Teewood Farm Barn
 Waddington

Proposed First Floor Plan

DRAWING NO. 046_PLN_202	REV C
-----------------------------------	-----------------

1 Scale: 1:50
 Proposed First Floor Plan

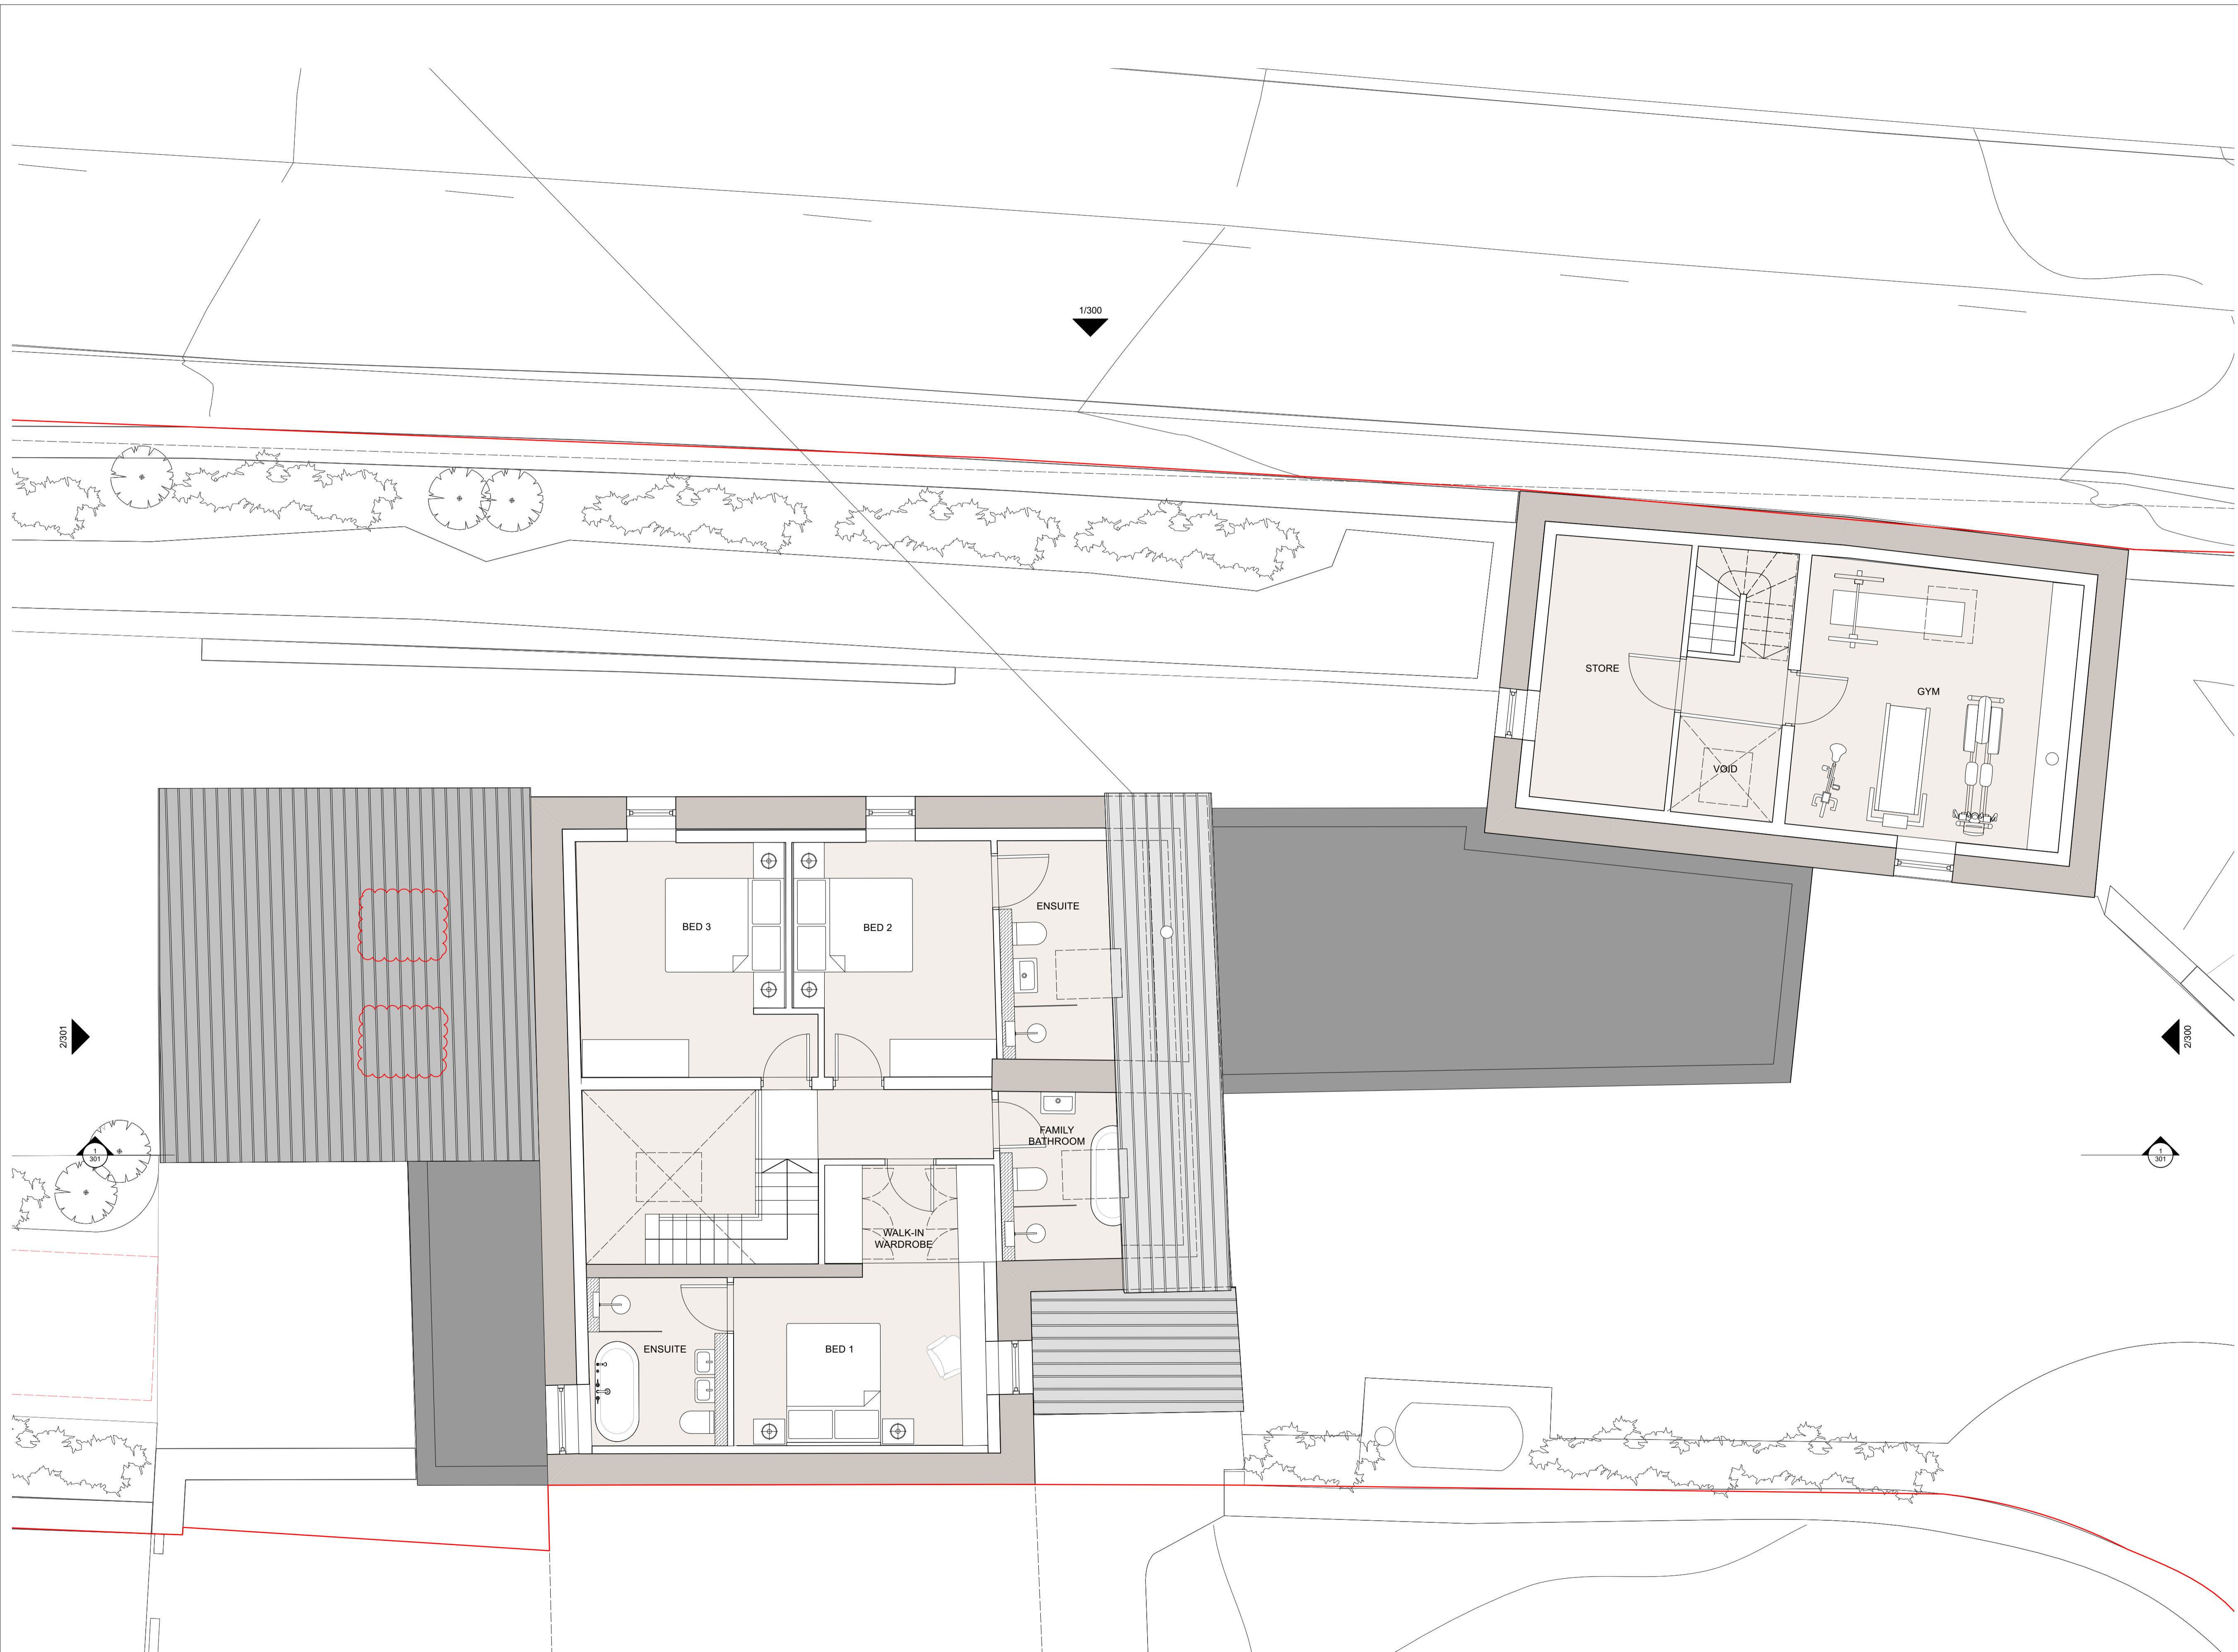
REV	DATE	NOTES
A	11/08/2022	ISSUED FOR PLANNING
B	25/05/2023	ROOFLIGHT OMITTED AND BIKE STORE ROOF SHOWN AS EXISTING IN RESPONSE TO LBC COMMENTS.
C	05/06/2023	2 NO. ROOFLIGHTS OMITTED IN RESPONSE TO LBC COMMENTS.
